City of Portland, Maine – Building or Use Permit Application 389 Congress Street, 04101, Tel: (207) 874-8703, FAX: 874-8716

DATE: 25 Sept 98 ADDRESS: 82 Curtis Rd. CBR 393-G-006
REASON FOR PERMIT: To Construct Porch 27'-0" x 16'
BUILDING OWNER: Whodon
CONTRACTOR: SAA
PERMIT APPLICANT: SAN
USE GROUP R-3 (Porch) BOCA 1996 CONSTRUCTION TYPE 5B

Porch proposed for:
 82 Curtis Road
 Portland, ME
 By Ralph Whedon 878-2655
 September 15, 1998

Side View

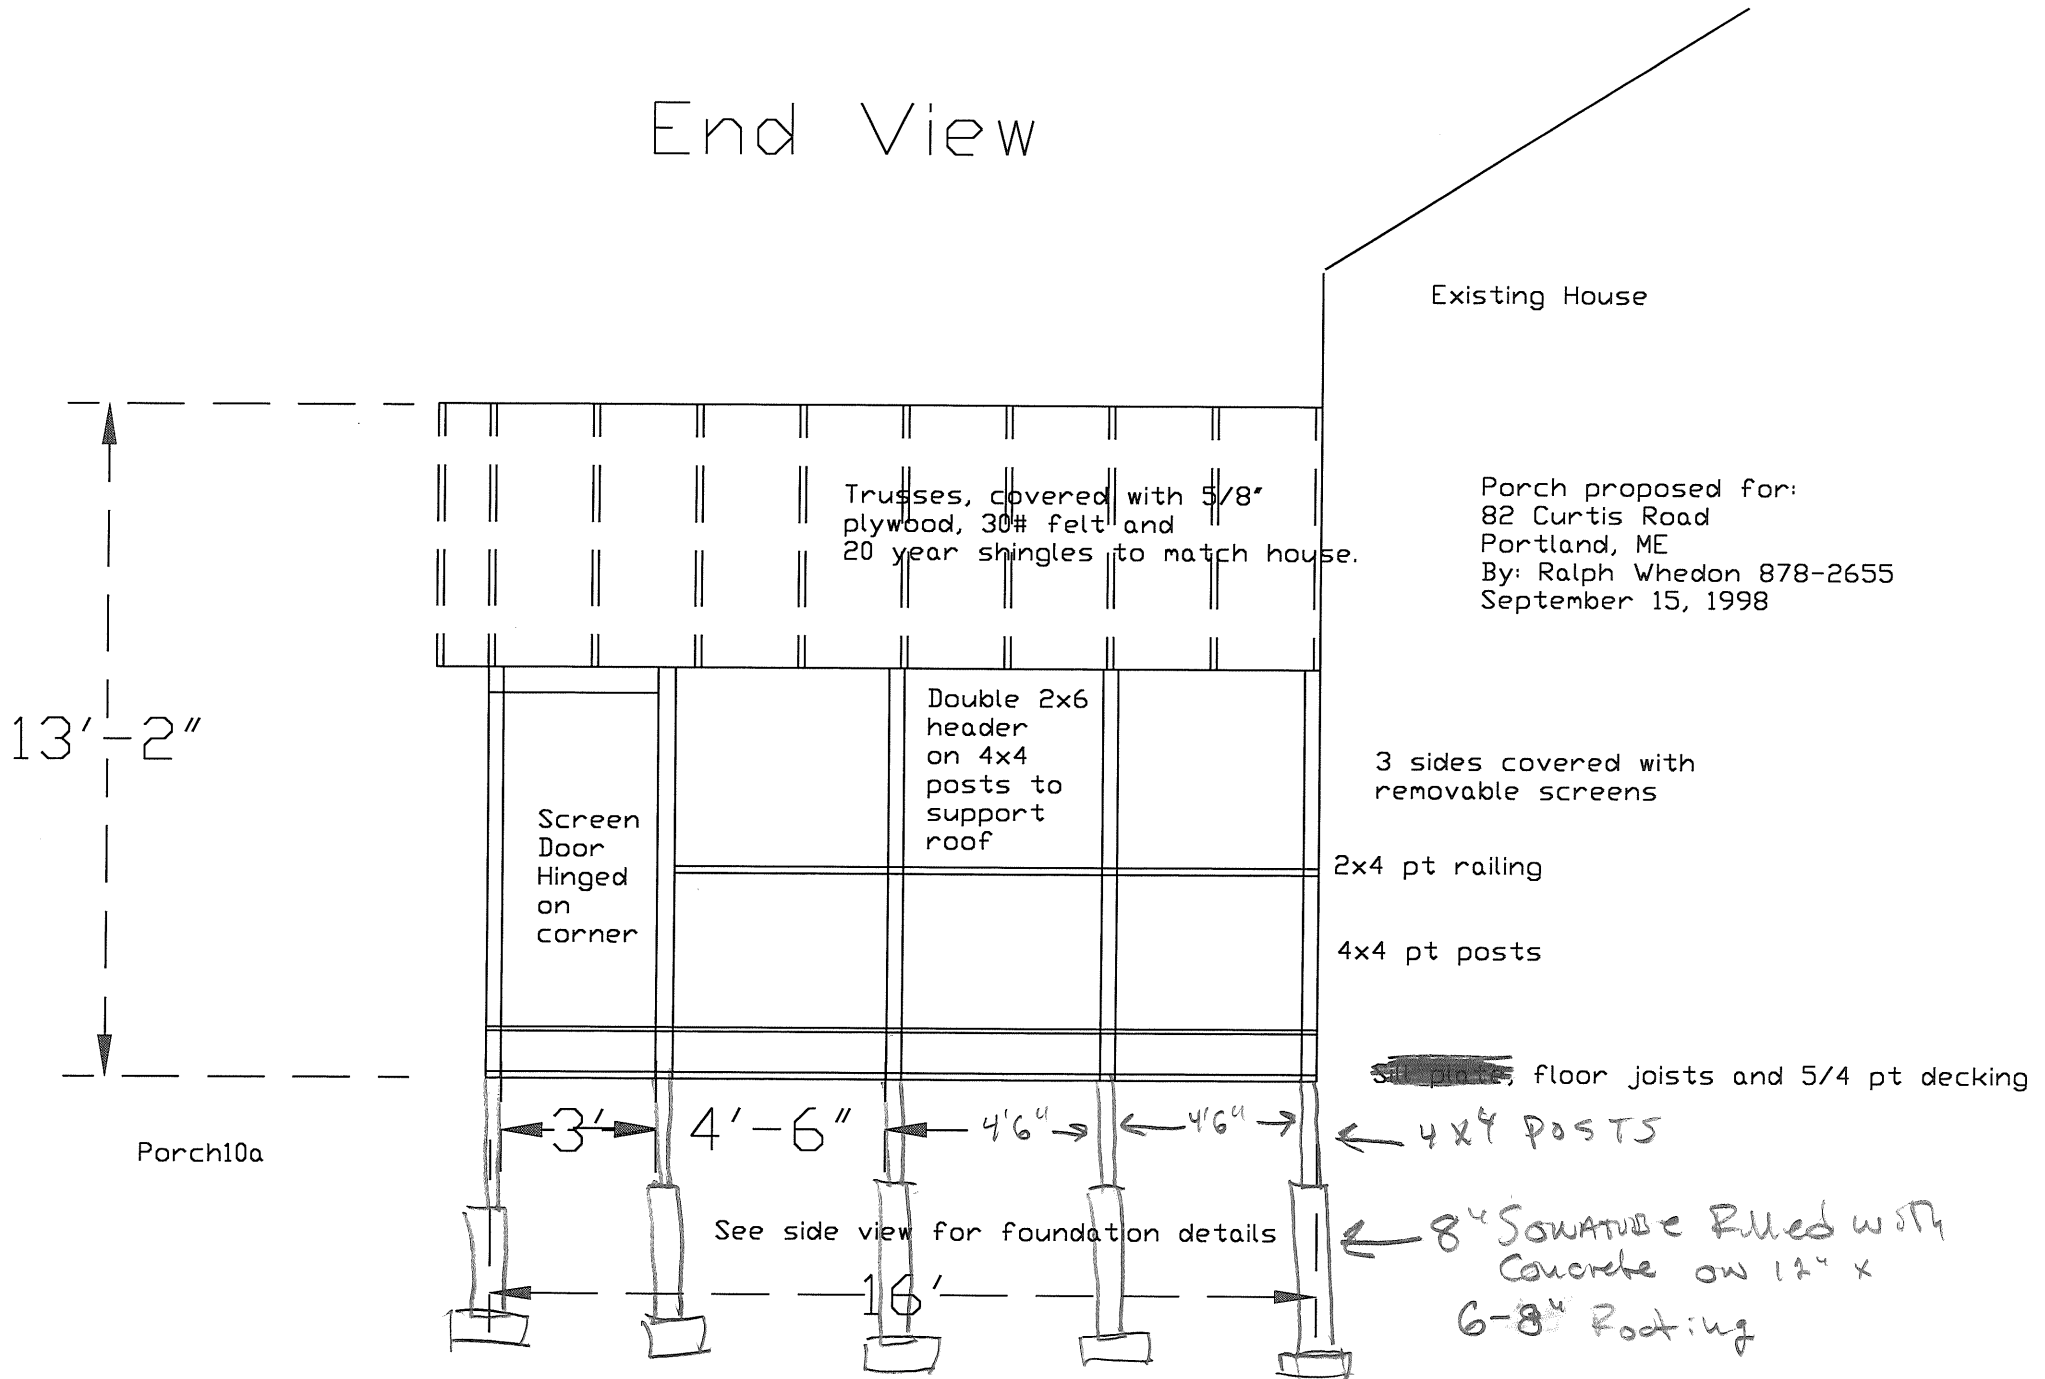
*29. The proposed Foundation system 8" piers (Squo Tubes) placed on Footing spaced a maximum of 4'6" o.c. - will have to have an engineers report ON ITS STRUCTURAL ability To Carry The proposed structure - The maximum size of a structure attached to a principal bldg. on Squo Tubes is 100 sq. ft. with an engineers report - Also your plans did not show 5124 carrying beam at center of structure, please submit this information before work begins -

Porch12

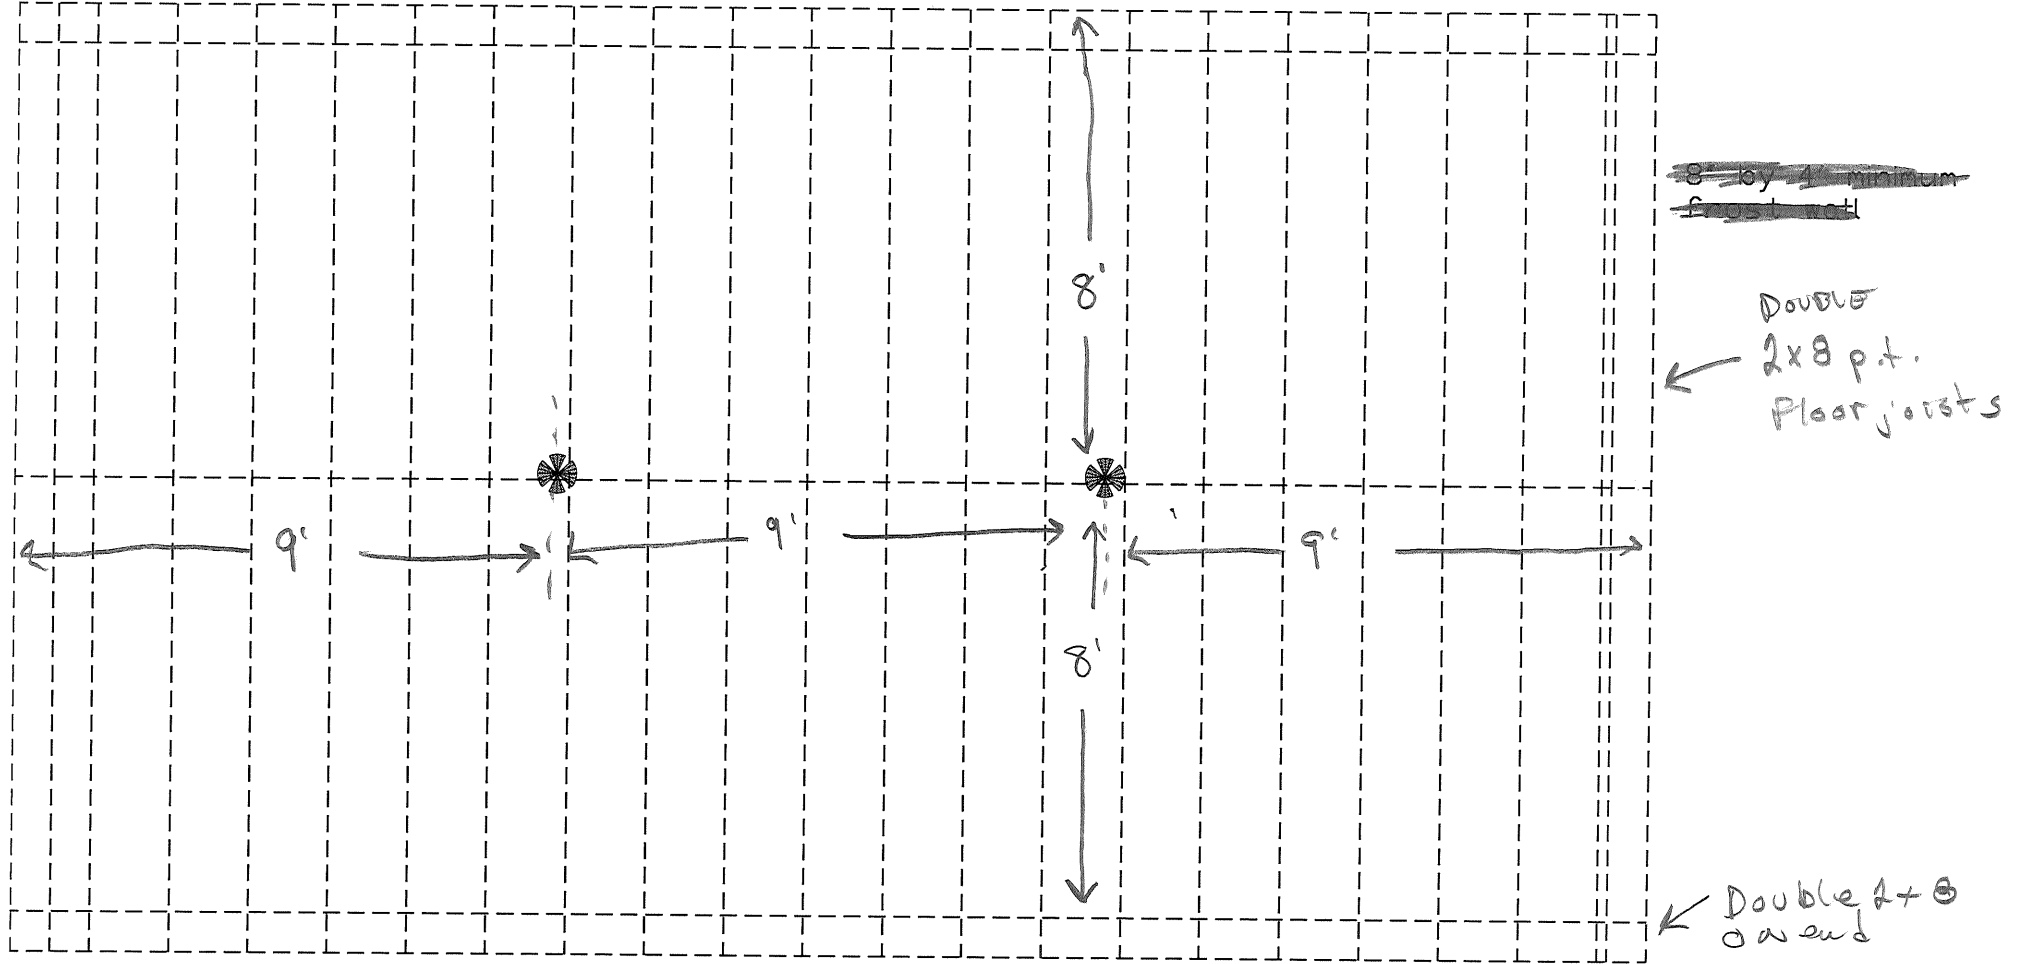
11-6-98 stopped by to check Deck I want more nailing attachment to house ledger. and Bridging attached to carrying beam

1. The engineer's report is attached.
2. The carrying beam is a double 2x8, (with support no further apart than every 10')

TYPICAL SONOTUBE DETAIL
1"=1'-0"

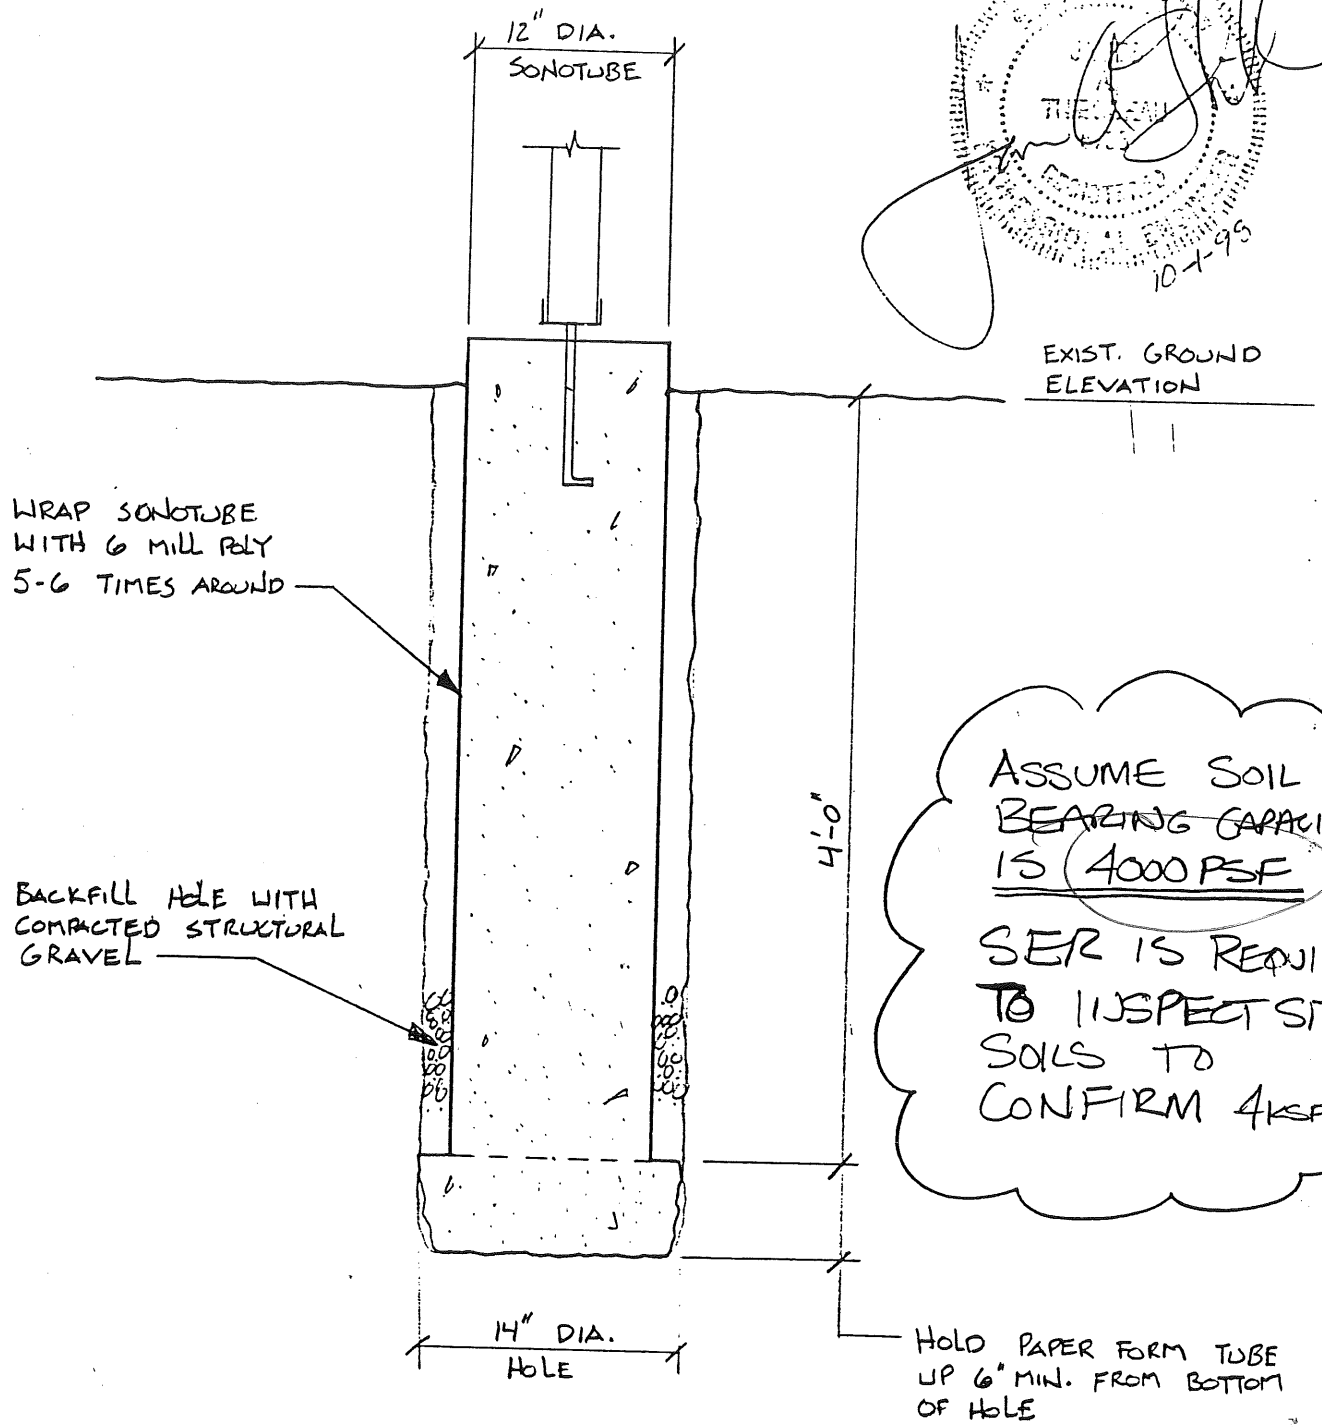
ASSUME SOIL BEARING CAPACITY IS 4000 PSF

SER IS REQUIRED TO INSPECT SITE SOILS TO CONFIRM 4KSF

REFERENCE PROPOSED BRCH DRAWINGS BY RALPH WHEEDON DATED SEPTEMBER 15, 1998.
LOAD ON SINGLE SONOTUBE NOT TO EXCEED 5000 #
